City of Coral Gables Planning and Zoning Staff Recommendation

Applicant:	4225 Properties, LLC and 4311 Ponce de Leon, LLC
Applications:	Mixed Use Site Plan Review (continued from October 8, 2014 Board meeting)
Property:	4225 and 4311 Ponce de Leon Boulevard (4311 Ponce)
Public Hearing - Dates/Times/ Location:	Planning and Zoning Board, November 12, 2014, 6:00 – 9:00 p.m., City Commission Chambers, City Hall, 405 Biltmore Way, Coral Gables, Florida, 33134

Mixed use site plan review for the mixed use project referred to as “4311 Ponce”, as follows:

PONCE DE LEON BLVD.
SITE LANDSCAPE PLAN
SCALE: $\frac{3}{32}$ " = 1'-0"

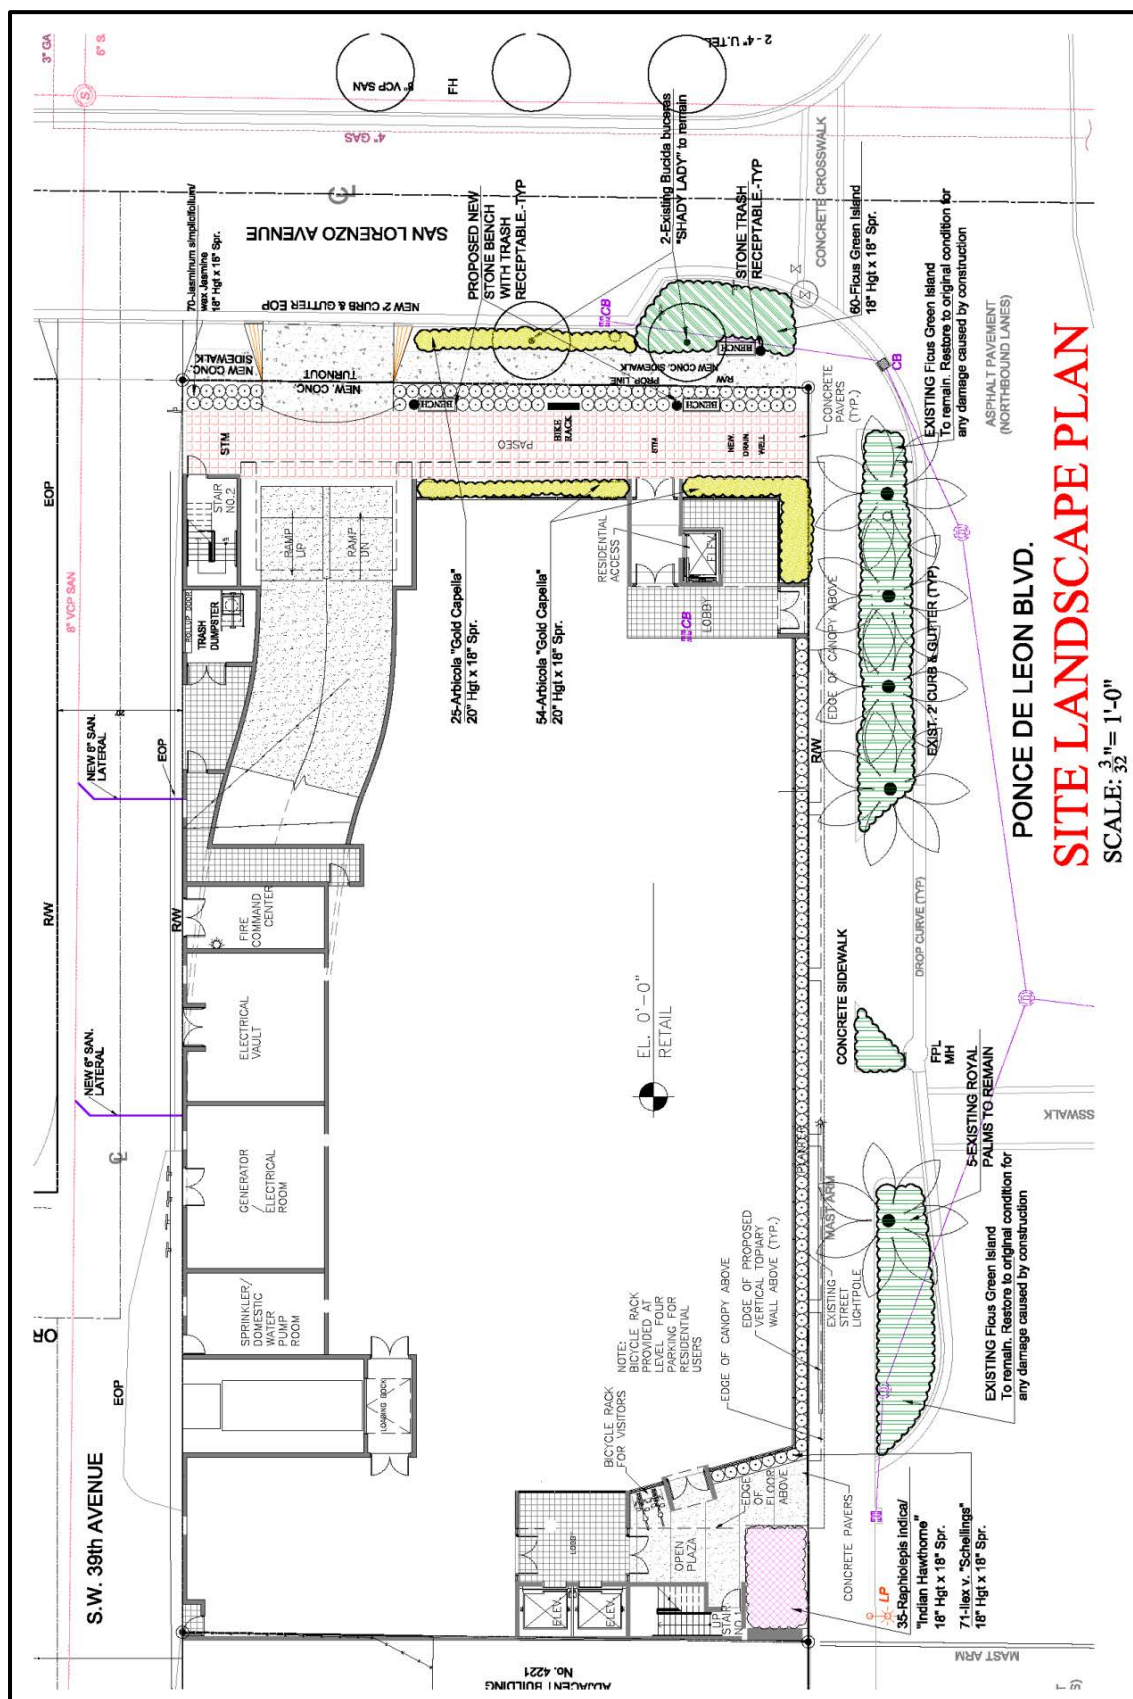
2. Planting bulb outs may be required at the alleyway and parking garage entrance on San Lorenzo Ave.
3. Some form of landscape needs to be incorporated on the street level in the alleyway. i.e. Creeping Fig growing on the walls, trellis structures with vines, etc.
4. Are the overhead wires in the alley way being relocated underground?
5. The balconies on levels five and six, particularly the east facing ones, need to have planters and irrigation incorporated into them since they face the blank wall of the adjacent building.
6. Consider screening the exposed parking on level four from the view of level five above.
7. The Residential Outdoor Plaza on level seven is confusing as to its purpose and functionality. What is the intended program/use for this vast covered area? More landscape should be considered to help define the space and enhance the functionality for the residents.

6. Since there is no tree canopy proposed within the property at the ground level, prior to the issuance of a building permit, a plan for small trees and/or palms on balconies, rooftops, and/or amenity decks need to be provided.

3. Subject to City approval of the right-of-way encroachment and Public Service and Public Works review, an 8"-12" planting area with irrigation along the base of the building fronting the ally shall be provided.

West (Ponce de Leon Boulevard) Building Elevation

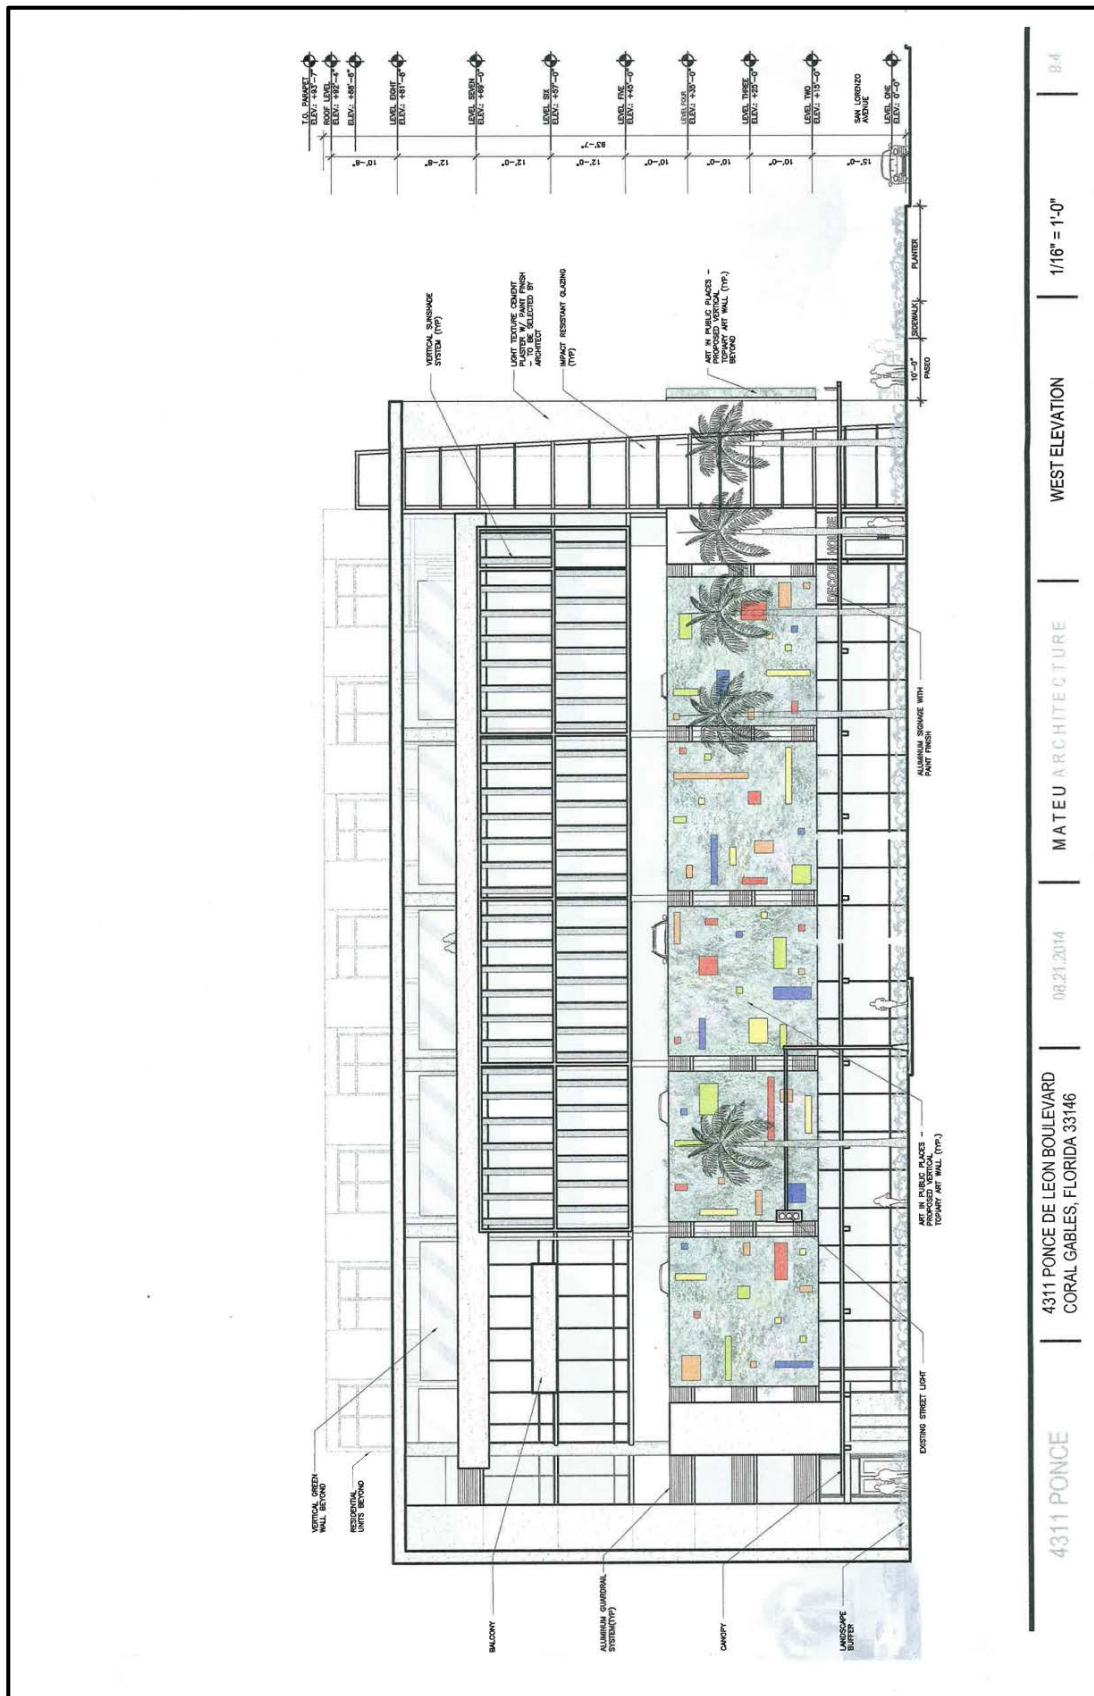
Currently, the project proposes a zero (0) foot front setback and 93'-7" building height, and does not provide a stepback on all building facades.

Staff comments: Since the proposed plans for the project were not revised, the project still does not comply with the requirements of the Zoning Code as identified in Item No. 1. Items No. 2 and No. 4 have been resolved. The comments provided by the Public Works Department regarding the Traffic Study have been satisfactorily addressed, and the Applicant held the required residents' meeting on 10.29.14. The Applicant provided responses to the comments concerning the landscaping identified in Item No. 3, and has proffered conditions that are acceptable to the Public Service Director. Those conditions are itemized in this Staff report, and would only be necessary if the Board recommends in favor of the Application.

- a. Provide the minimum ten (10) foot front setback for the entire building along the front property line (Ponce de Leon Blvd). A minimum front setback of ten (10) feet is required for buildings over forty-five (45) feet in height; or
- b. Comply with Zoning Code Section 4-201.E.15 for setback reductions. Applicant may provide zero (0) foot setbacks on all sides if vertical building stepbacks of a minimum of ten (10) feet are provided at a maximum height of forty-five (45) feet on all building facades.

West (Ponce de Leon Boulevard) Building Elevation

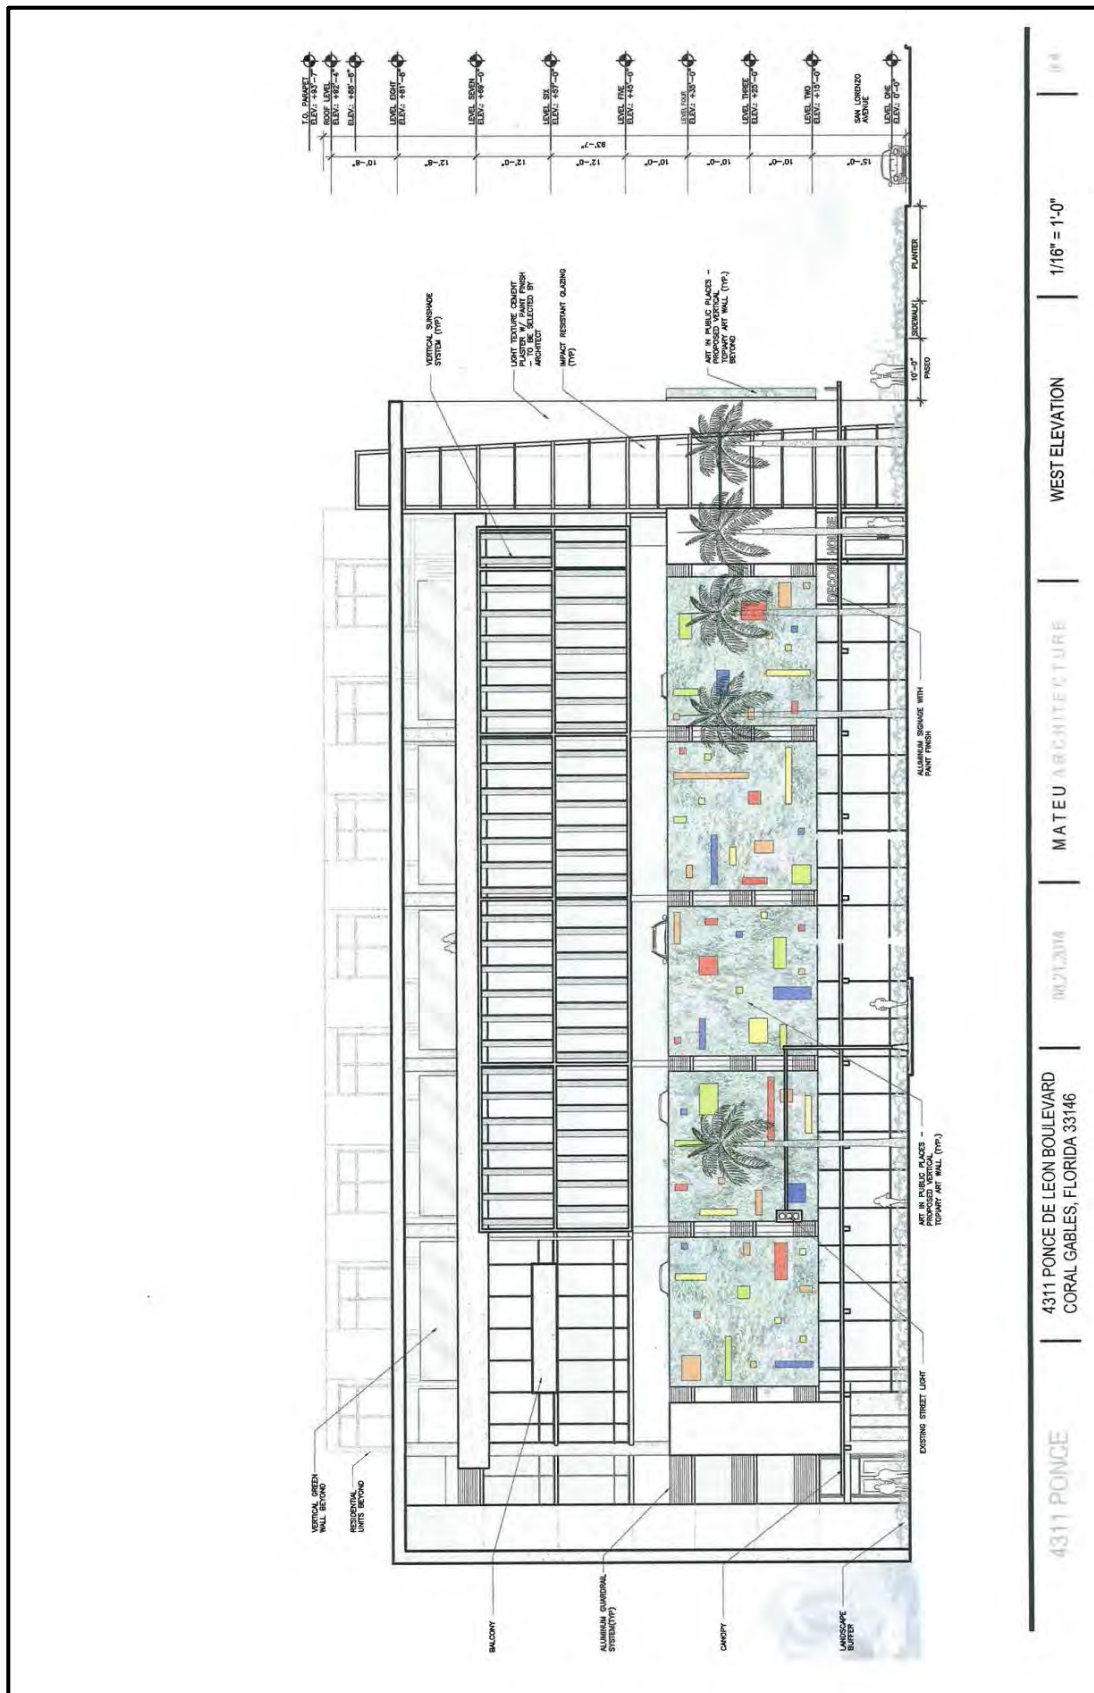
Currently, the project proposes a zero (0) foot front setback and 93'-7" building height, and does not provide a stepback on all building facades.

1. Provide the minimum ten (10) foot front setback for the entire building along the front property line (Ponce de Leon Blvd). A minimum front setback of ten (10) feet is required for buildings over forty-five (45) feet in height.

2. Comply with Zoning Code Section 4-201.E.15 for setback reductions. Applicant may provide zero (0) foot setbacks on all sides if vertical building setbacks of a minimum of ten (10) feet are provided at a maximum height of forty-five (45) feet on all building facades.
